TRANS/WP.29/2002/7/Rev.1/Corr.1
19 December 2002

PROPOSAL FOR A NEW DRAFT REGULATION:

UNIFORM PROVISIONS CONCERNING THE APPROVAL OF TYRES
WITH REGARD TO ROLLING SOUND EMISSIONS

Revision 1 - Corrigendum 1

"Example 3

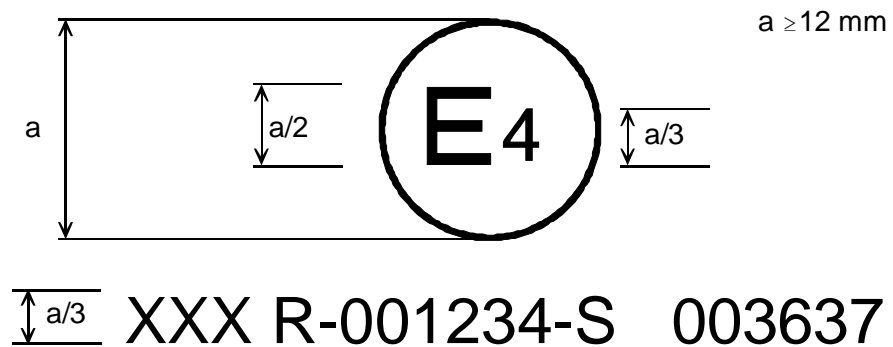
Annex 2, Example 3, correct to read:

The above approval mark shows"
